DEVELOPMENT ASSESSMENT REPORT Shire of Augusta Margaret River 16 May to 22 May 2024

Development Assessment P224159

Address	15 Tryone Loop, Margaret River				
Proposed Development	Outbuilding (Shed)				
Zoning	R15 Residential				
Lot Area	948sqm				
Use Class and Permissibility	'P' Permitted				
Heritage/Aboriginal Sites	none				
Other Considerations	Visual Management Area		Sewerage Sensitive Area		
	Special Control Area		Watercourses/Rivers		
	Bushfire Prone Area	X	Environmentally Sensitive		
			Areas		
Structure Plans/LDP's	SPA 17 - Outline Developmer	nt Plan	Area No.8 Provisions Lot 51 V	Vise	
	Road and Lot 52 Wallcliffe Ro	bad			
Easements/Encumbrances	Stormwater easement on front of lot – does not affect this proposal				
Why is Development Approval	Within 10m rear setback land	scape l	ouffer – as per SPA 17

Figure 1 2004 aerial image prior to subdivision approval.

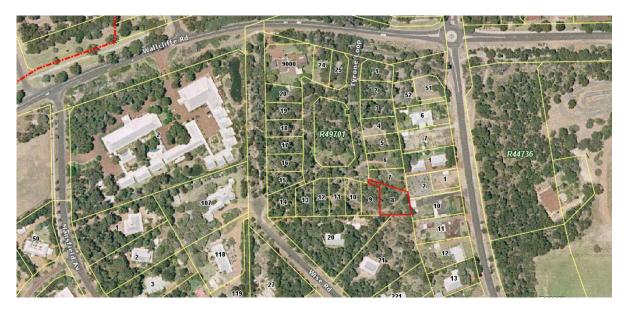
Figure 1 above shows the site prior to subdivision approval and demonstrates the amount of vegetation on the block at the time of subdivision approval. It also shows the differences in the zoning between the higher density R15 residential lots and lower density R5 lots to the South & West. Protecting and maintaining vegetation on the site throughout was a key condition of the subdivision, demonstrated by the incorporation of item 5 in the outline development plan.
